**MAINE TURNPIKE AUTHORITY**

**ADDENDUM NO. 2**

**CONTRACT 2019.04**

**INTERCHANGE 103 BARRIER TOLL PLAZA**  
**OPEN ROAD TOLLING CONVERSION**  
**MILE 103.00**

SOUTHBOUND PROFILE 5

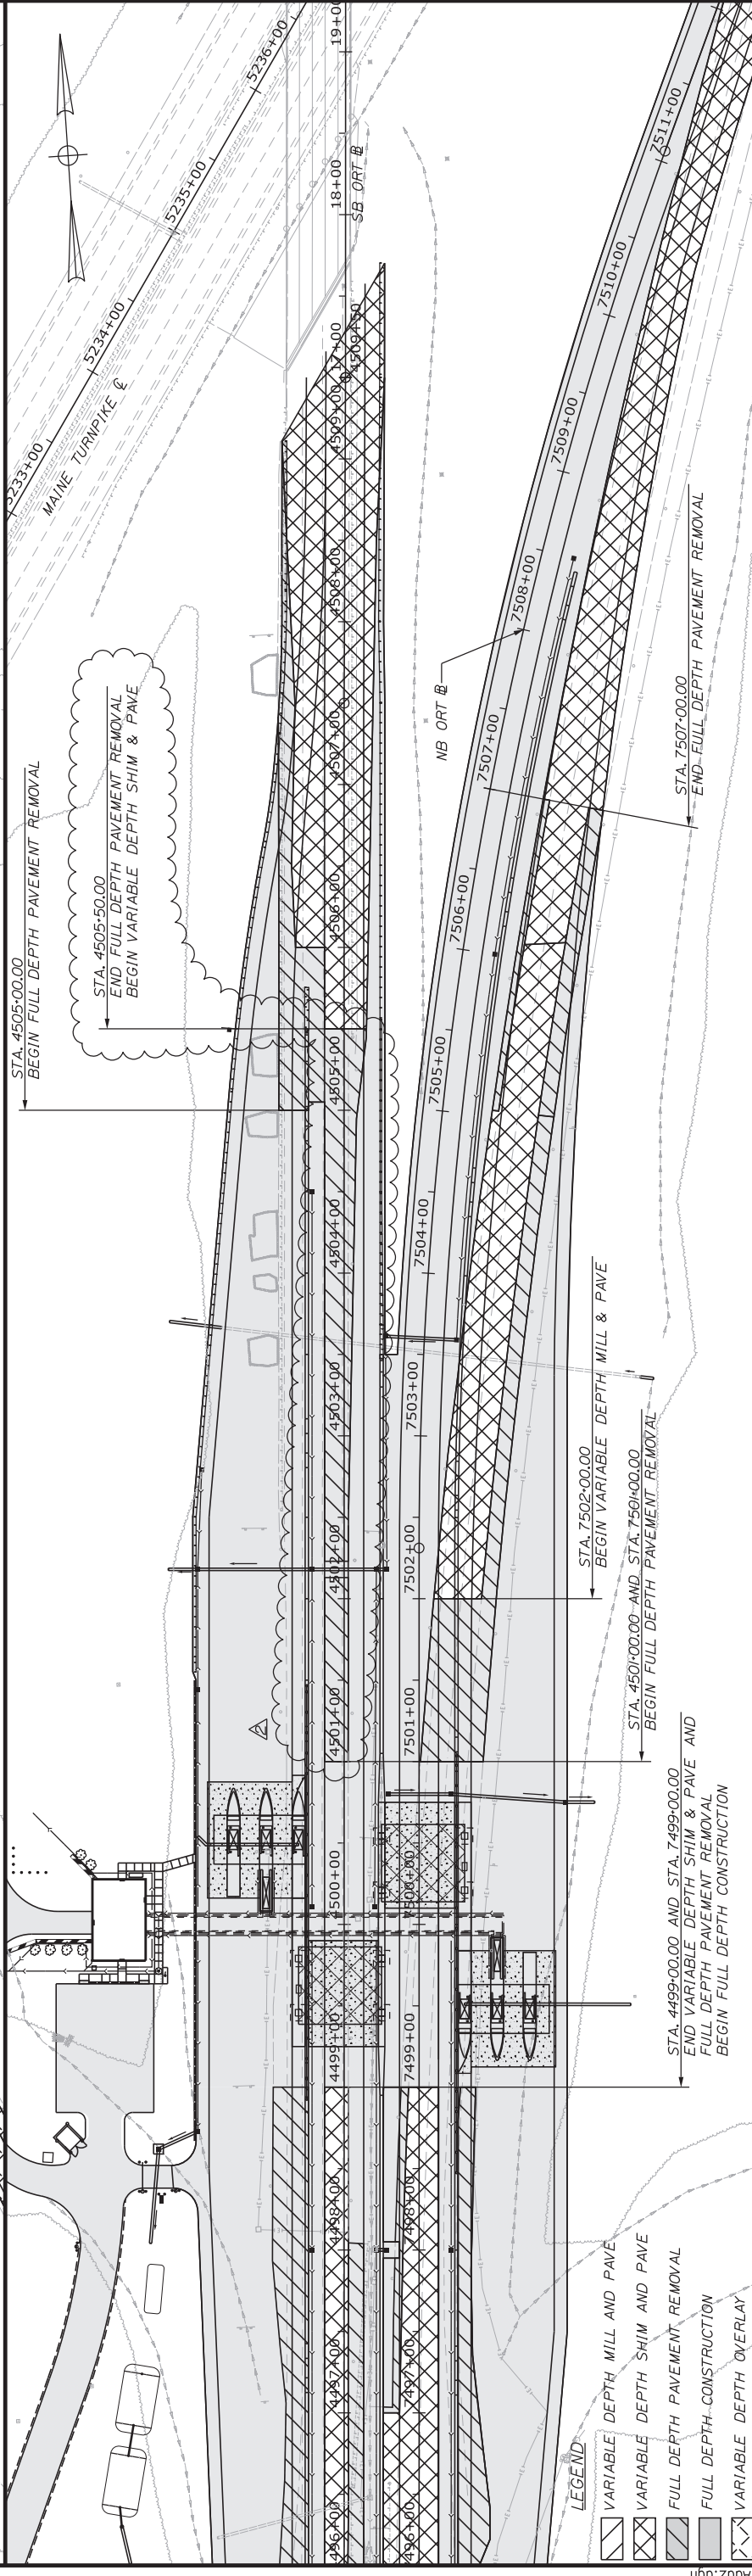
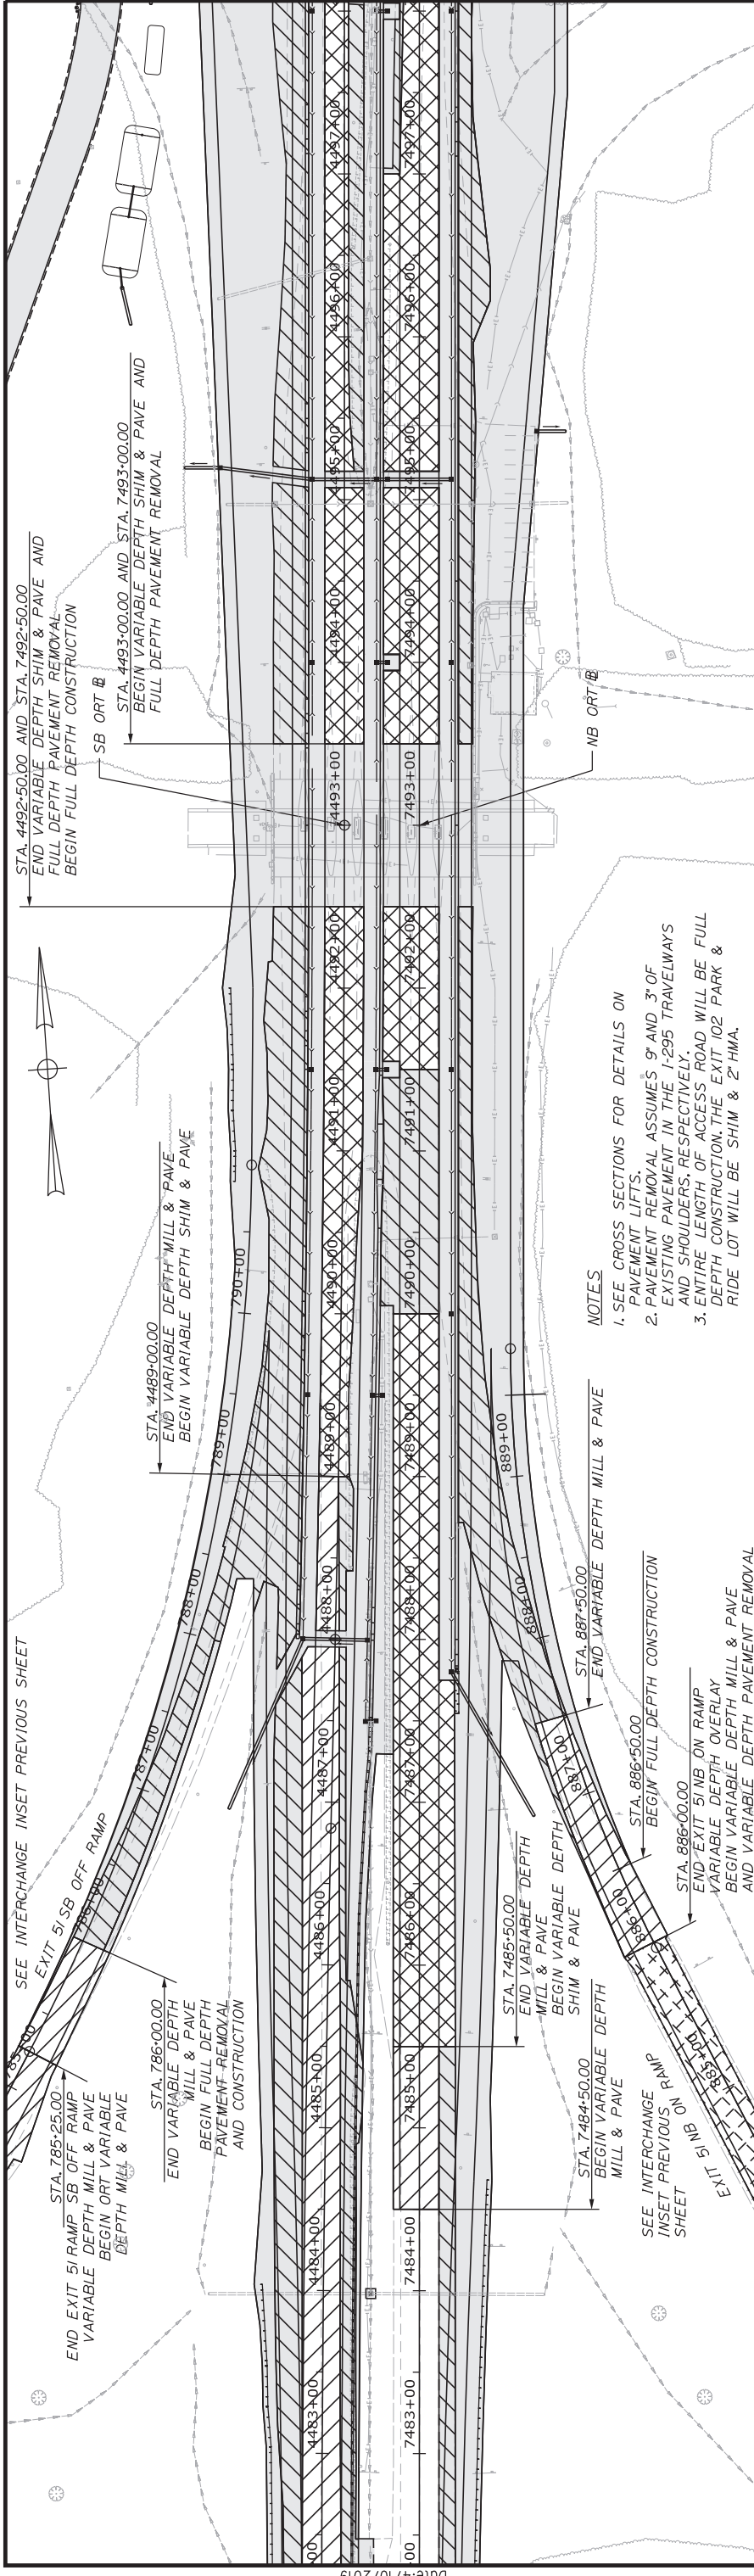
- Plan Sheets 143 and 144 of 503, SOUTHBOUND PROFILE 4 AND 5, have been deleted in their entirety and replaced with Plan Sheets 143 and 144 of 503, included in this addendum.

No.	Revision	By	Date
1	PAVEMENT DEPTH CHANGE	PLP	4/19

PAVEMENT PLAN 2

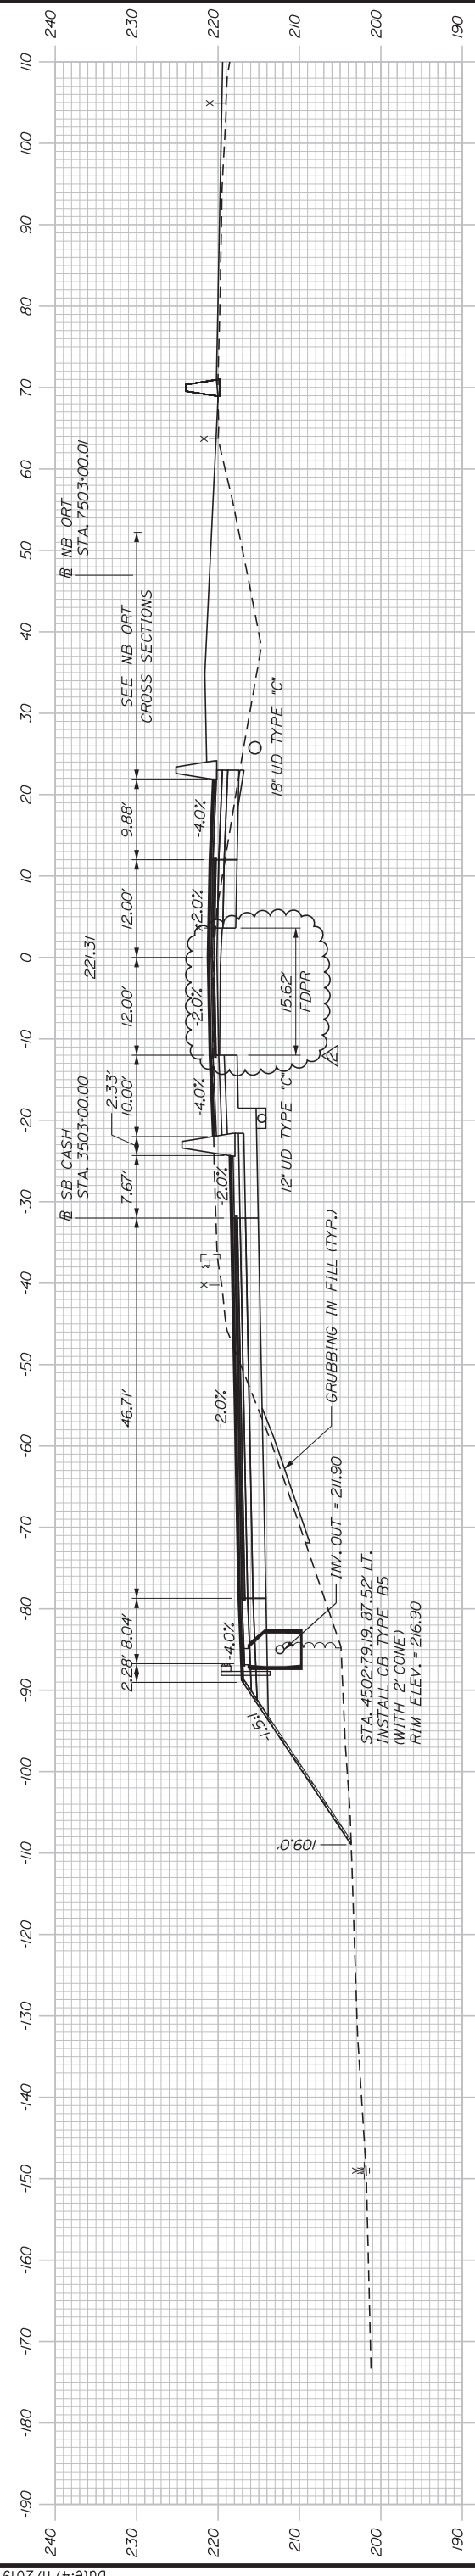
- Plan Sheet 169 of 503, PAVEMENT PLAN 2, has been deleted in its entirety and replaced with Plan Sheet 169 of 503, included in this addendum.
- Plan Sheets 277 and 278 of 503, NB/SB ORT STA. 4500+80/7500+80 TO STA. 4501+50/7501+50, NB/SB ORT STA. 4502+00/7502+00 TO STA. 4502+00/ 7502+00, have been deleted in their entirety and replaced with Plan Sheets 277 and 278 of 503, included in this addendum.

SHEET NUMBER: XS-45  
279 OF 503

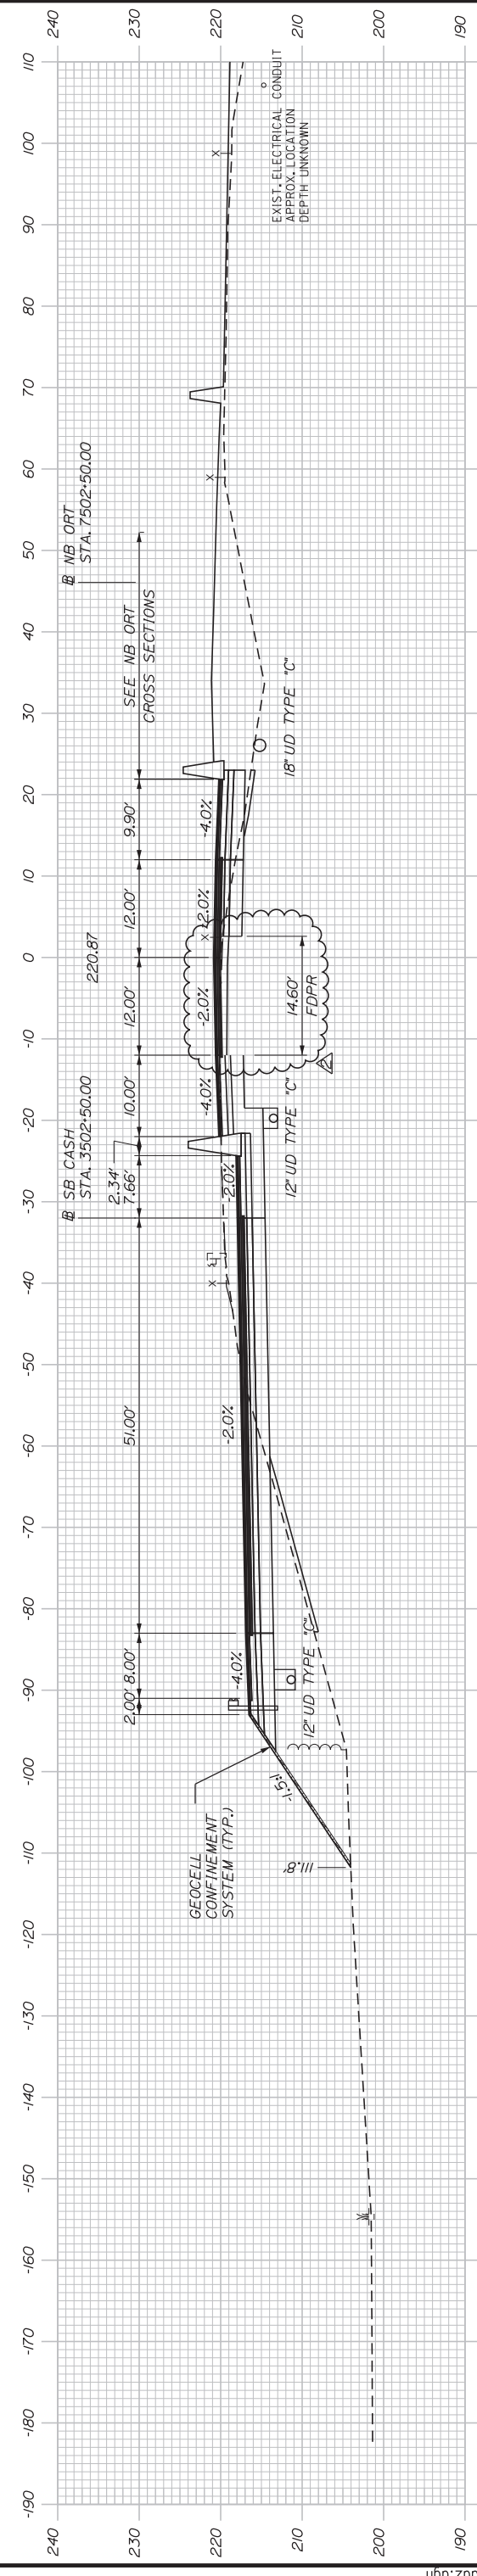
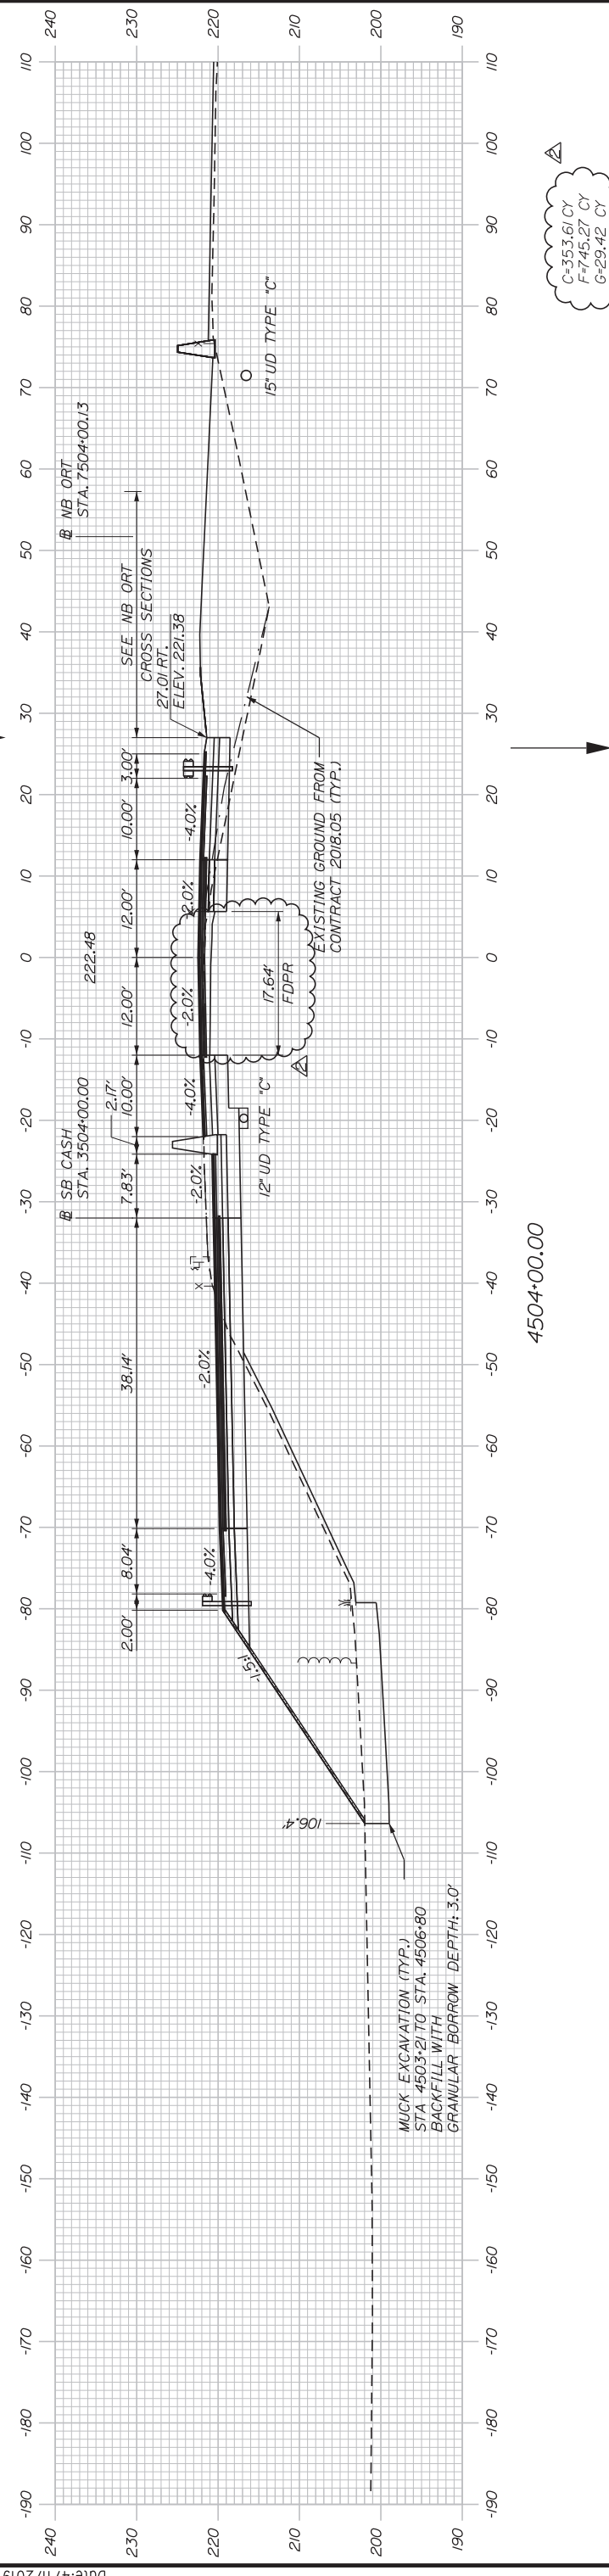
- Plans Sheets 279, 280 and 281 of 503, SB ORT STA. 4502+50.00 TO STA. 4503+00.00, SB ORT STA. 4503+50.00 TO STA. 4504+00.00 and SB ORT STA. 4504+50.00 TO STA. 4505+00.00, have been deleted in their entirety and replaced with Plan Sheets 279, 280 and 281 of 503, included in this addendum.

No.	Revision	By	Date
1	PAVEMENT DEPTH CHANGE	PLP	4/19

CONTRACT: 2019.04  
SHEET NUMBER: XS-46  
280 OF 503

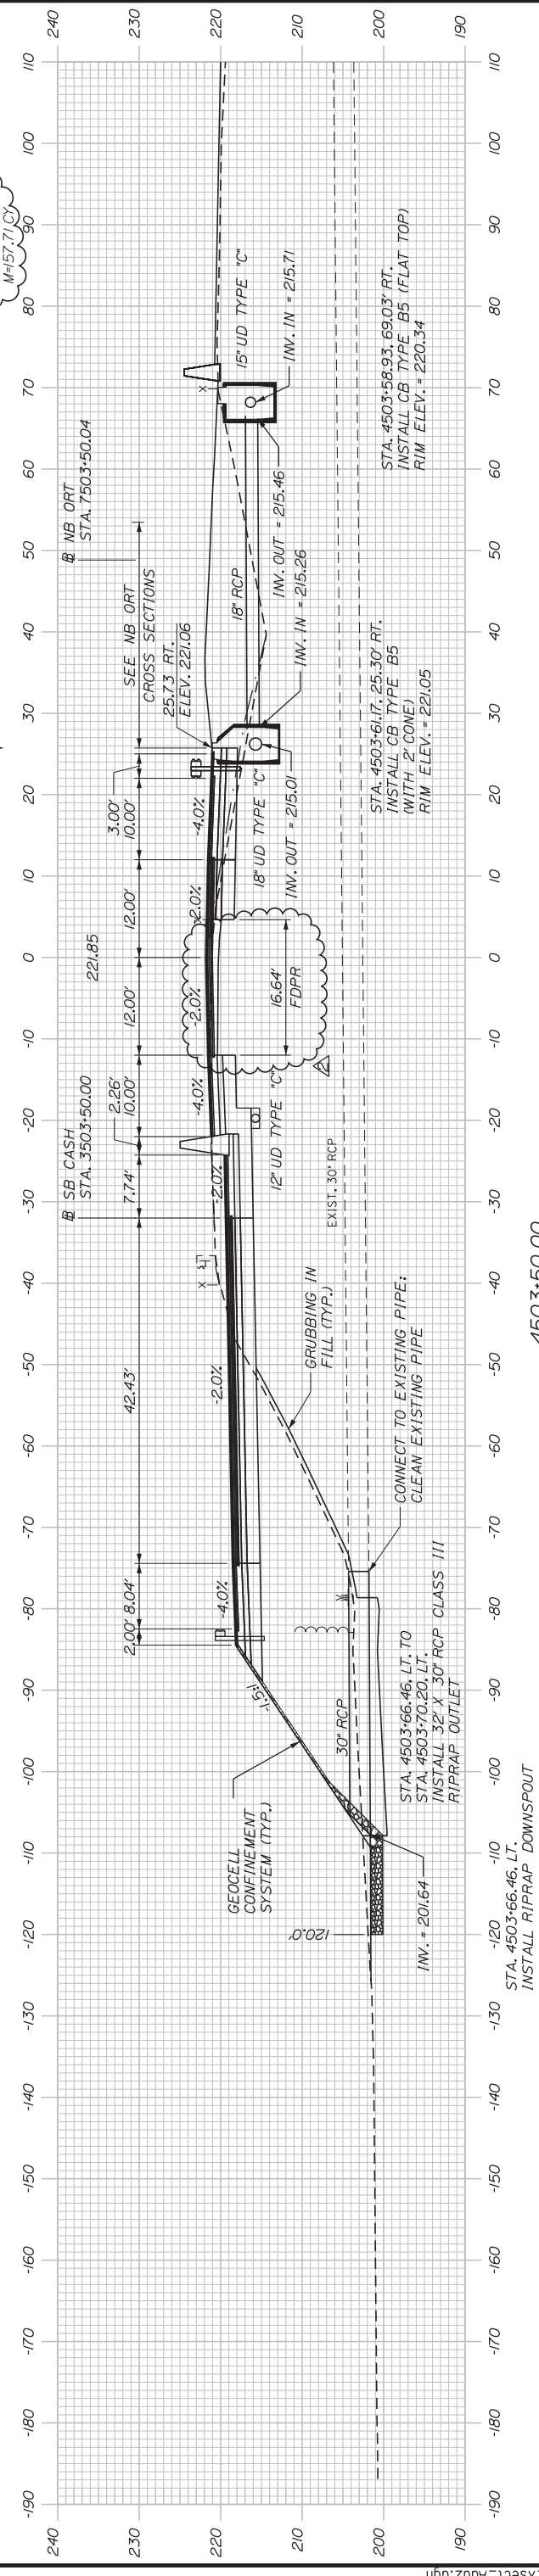
No.	Revision	By	Date
1	PAVEMENT DEPTH CHANGE	PLP	4/19

**ASK-1**

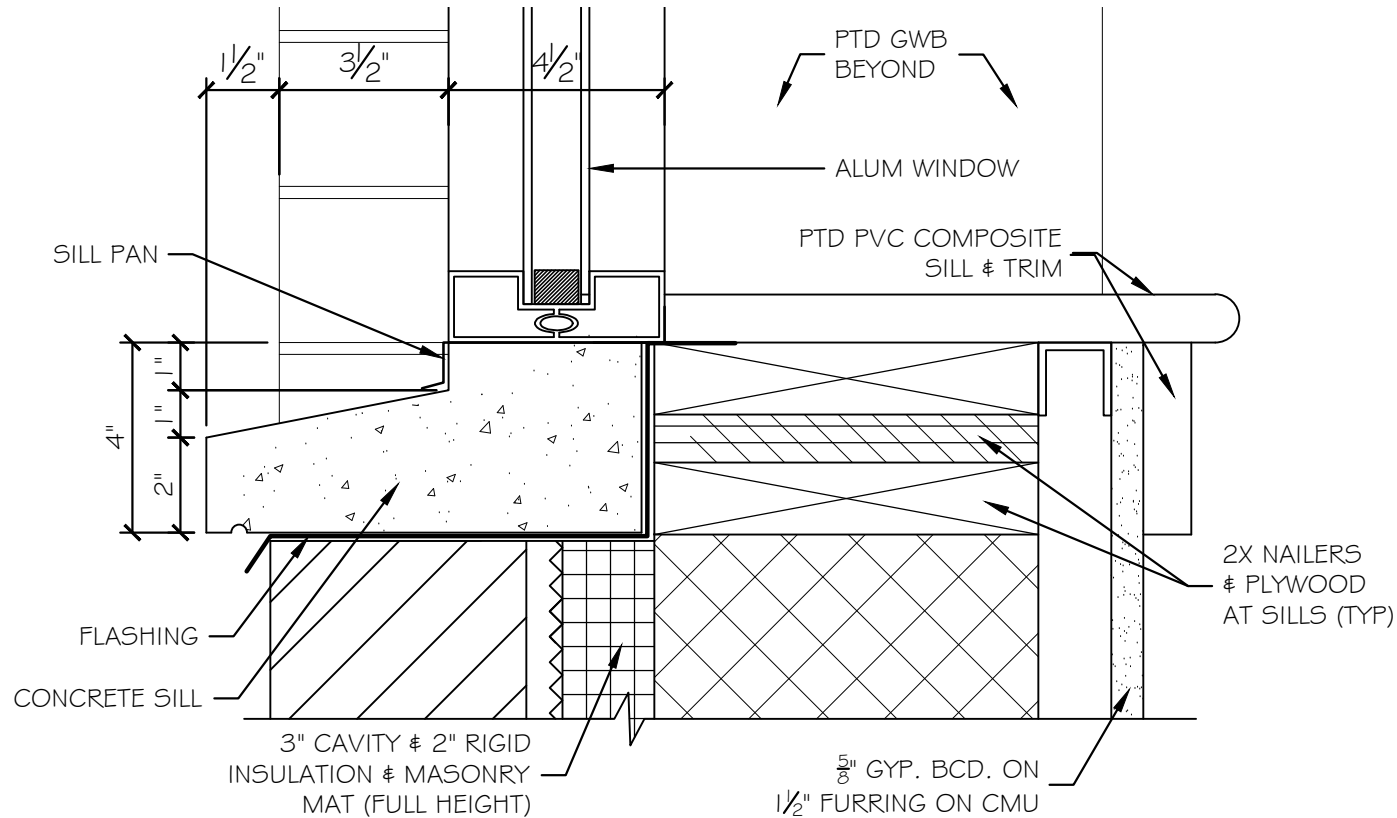
- ASK1, included in this addendum, has been added with revisions to the dimensions of the precast sill.

REVISION TO  
EXTERIOR  
WINDOW SILL
